STAFF RECOMMENDATION
1830 5th Avenue North
January 20, 2021

Application: Demolition
District: Salemtown Neighborhood Conservation Zoning Overlay
Council District: 19
Map and Parcel Number: 081 08 0M 002.00
Applicant: Jeff Zeitlin
Project Lead: Paul Hoffman, paul.hoffman@nashville.gov

<p>Description of Project: Applicant proposes to demolish a contributing building.</p> <p>Recommendation Summary: Staff recommends approval of the proposed demolition, finding basic repairs will result in the complete loss of the historic building, resulting in the project meeting V.B.2 (a) for appropriate demolition.</p>	<p>Attachments</p> <p>A: Photographs B: Estimates for repair C: Engineer’s reports D: Inspection report E: Comparables</p>
---	--

PHOTOS

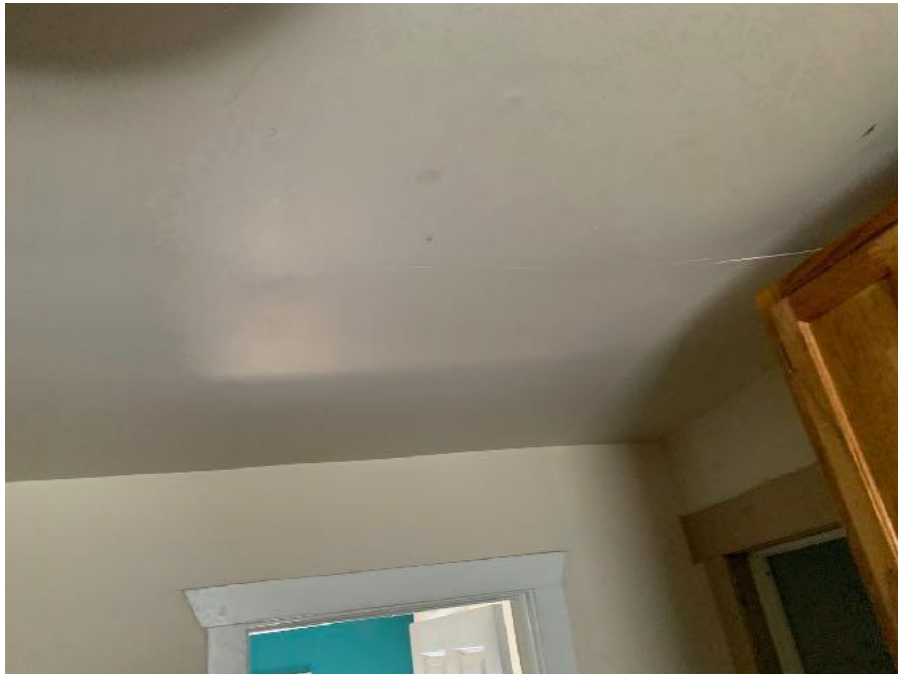
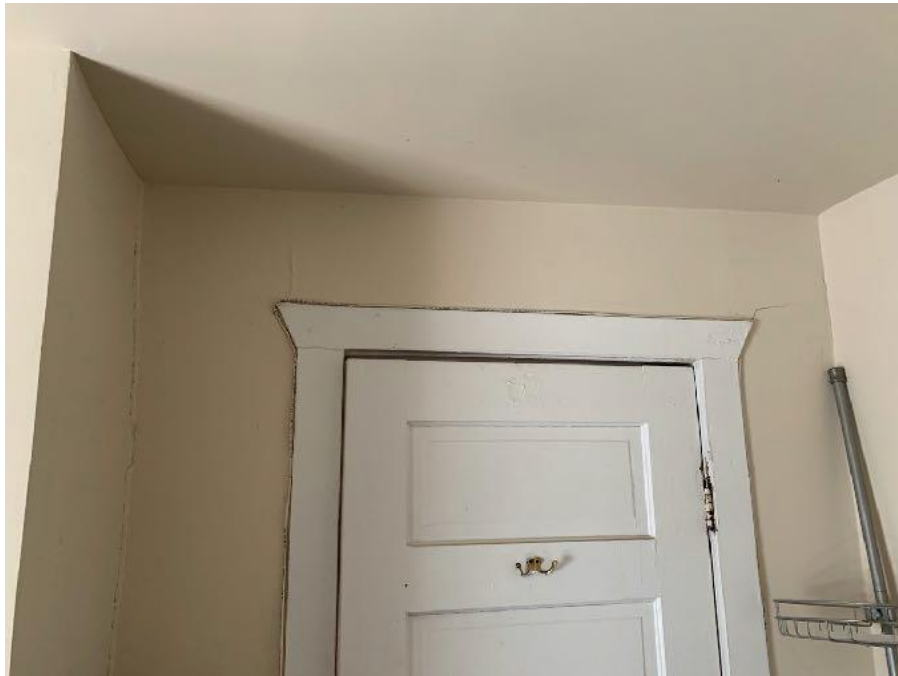
Foundation & Floors: Access underneath the structure is limited. The perimeter foundation is in good condition. The block foundation was laid with two blocks, but the lower block is mostly below grade, resulting in the wooden support elements being as close as six inches (6”) from the ground. The visible portion of the floor support structure exhibits water damage, termite tracks and has been cut through in places either for repairs or for installation of mechanical work. Although only a portion of the crawl space is visible, staff and the engineer reports estimate deterioration, water intrusion and termite damage to a significant percentage of the beams and joists that would likely require replacement, based on what can be seen on the interior. The engineer’s report notes the floor slopes half an inch (½”) over a four-foot (4’) length toward the center of the building. Floors that have fallen out of level are common in an historic structure, but typically, this much drop is considered problematic over a length of twenty feet (20’), essentially the entire width of the building.

Framing/Siding: The wall framing is not visible. The interior framing exhibits the same sagging visible in the floors, between half an inch (1/2“) to an inch (1”) over the span of a door frame. In one location, Mr. Sandhu observed horizontal framing where it should be diagonal and he states that all ceiling joists need to be replaced, just to place mechanicals in the attic space.

View of 2x4 rafters, poorly installed siding

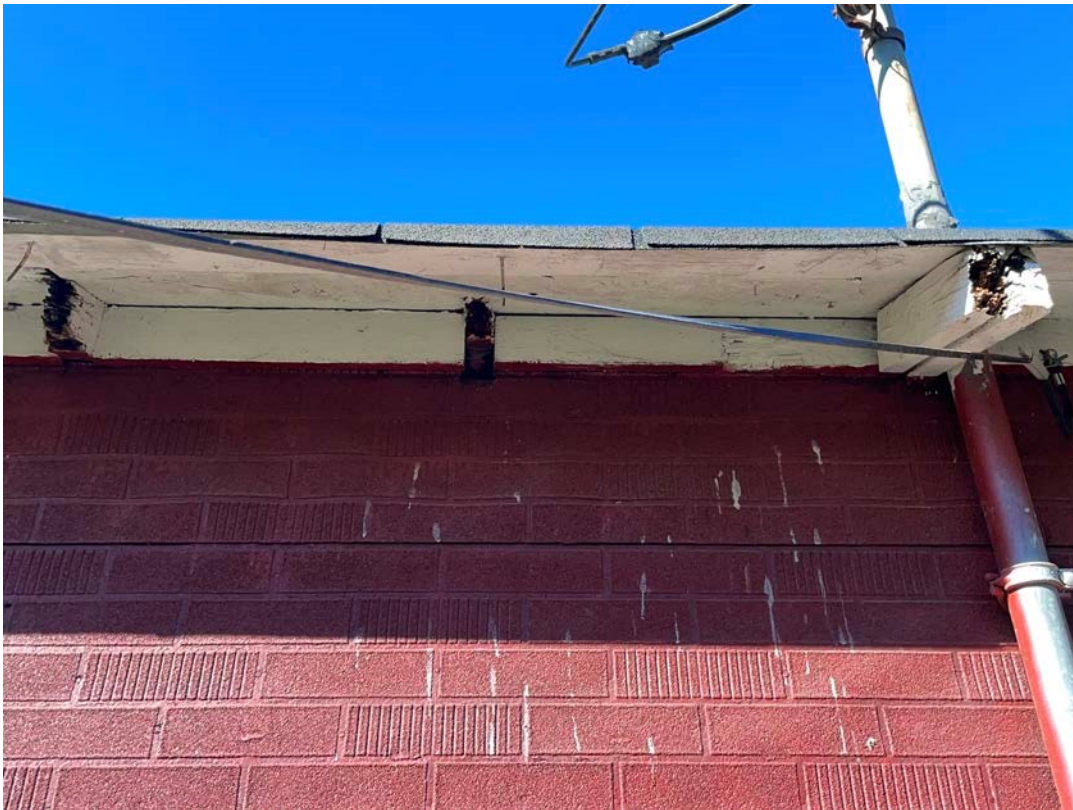
CMU Block Foundation Height less than 12"
